CERTIFICATE OF APPROPRIATENESS

Property: 700 Euclid Street, Lots 1 & 2, Block 37, Woodland Heights Addition. The property includes a historic 2,666 SF, two-story wood single-family residence and detached garage situated on a 15,130 SF (100' x 151.3') corner lot.

Proposal: Alteration – Addition

The applicant is proposing a 902 SF rear addition to existing structure.

ATTACHMENT A

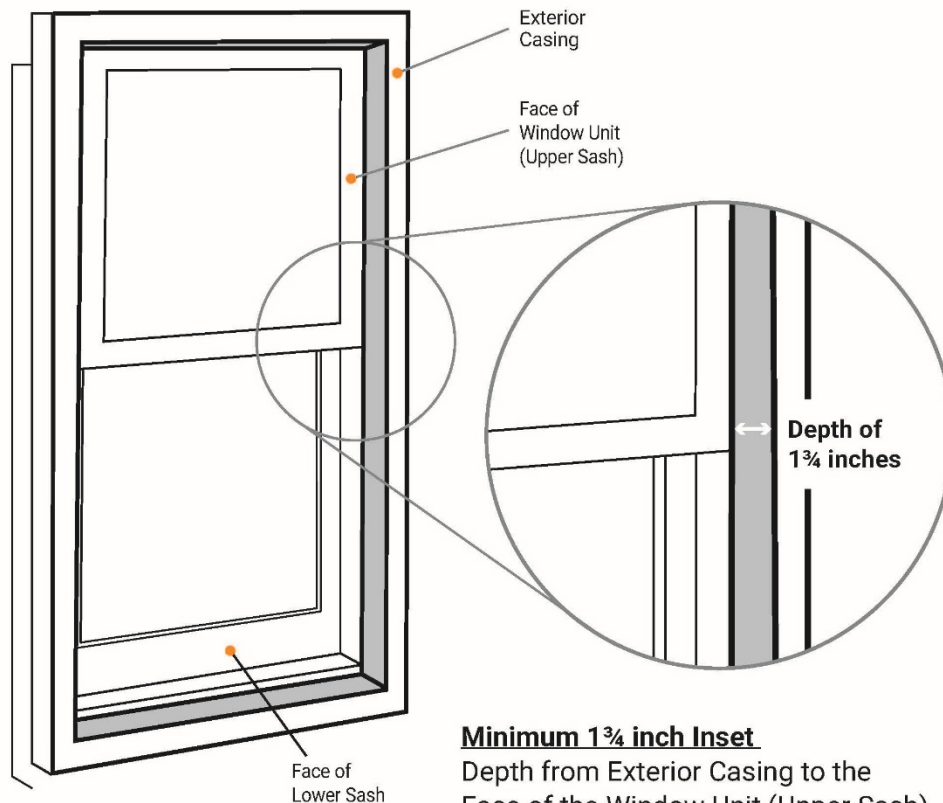
- Roof: non-original clay tiles with 7/12 pitch; replacing roof with composite shingles
 - Design extends the existing roof framing and maintains the 7/12 slope
- Eave: 23'-7" to be maintained
- Peak ridge of roof: 34'-0", matches existing
- Ceiling height: ground floor 10'-5", to be maintained in renovated first-floor areas.
 - Second-floor ceiling height is 10'-0" to also be maintained in addition
- Siding: Wood siding; match siding with fibrous cement siding for the addition
- All new windows should be inset and recessed. See Attachment A.

Historic Window Standard: New Construction & Replacement

Minimum 1 3/4 inch Inset

Windows must be 1-over-1
(equally horizontally divided)

1 3/4 inch minimum inset for Fixed Window
